# Modification Recommended Service Note

Supersedes:  
E1467A-01

## E1467A 8x32 Relay Matrix Switch

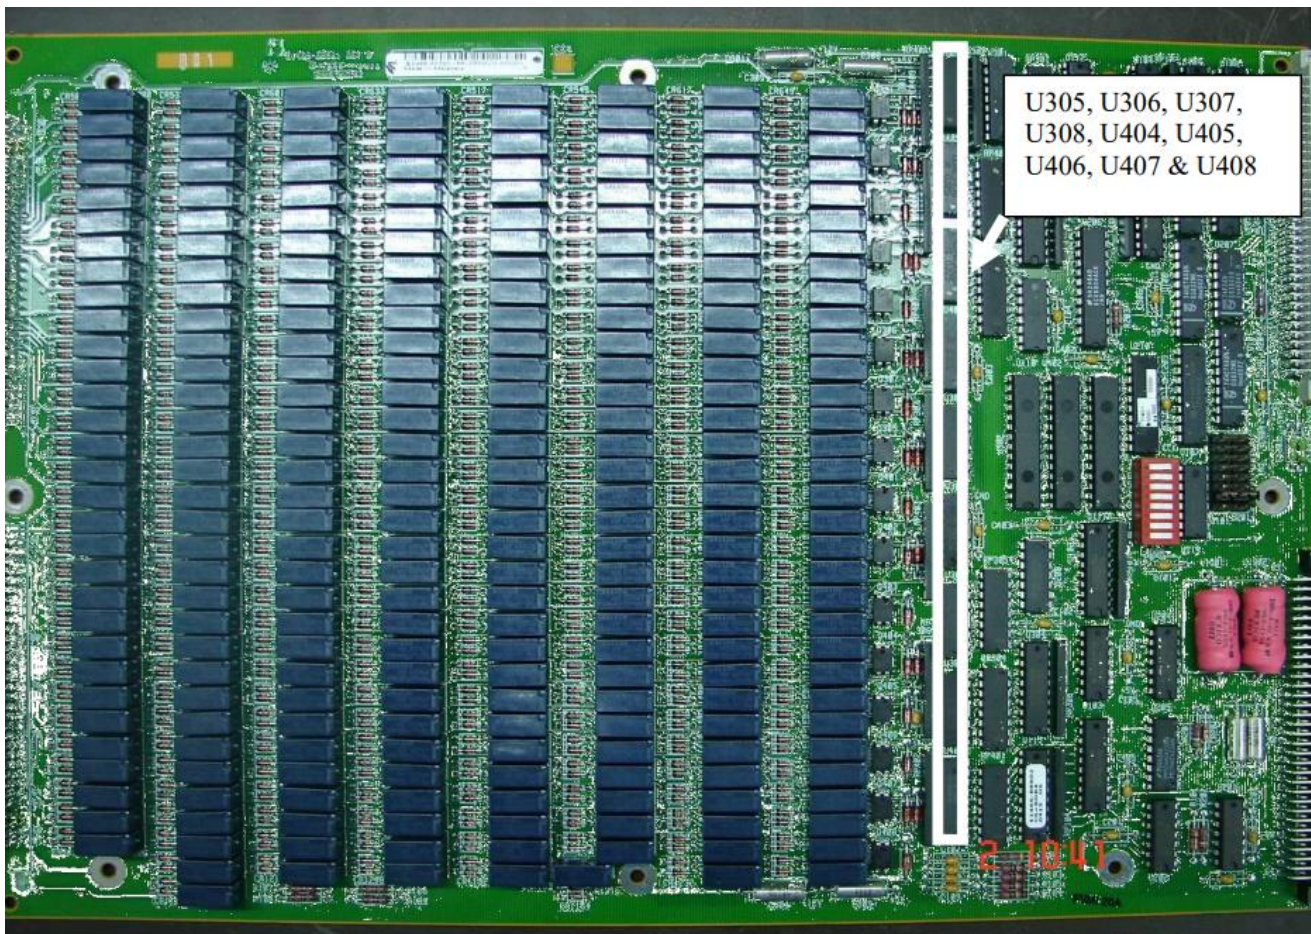
The relay driver ICs are U305, U306, U307, U308, U404, U405, U406, U407, and U408 which are the LTB part 5188-2550 for 1820-4599.

The bad date code is 0325. This date code has a much higher failure rate. Most failures have occurred in the first three months of usage. See the following pictures for part and date code location.

Part Number : E1466-66501  
Location Impacted : U305, U306, U307, U308, U404, U405, U406, U407, and U408

Reject Criteria : DC 0325 on IC

A E1467A that fails to close or open it's relays and has the 0325 date code ICs should be replaced with a E1466-66701 or E1466-69701.
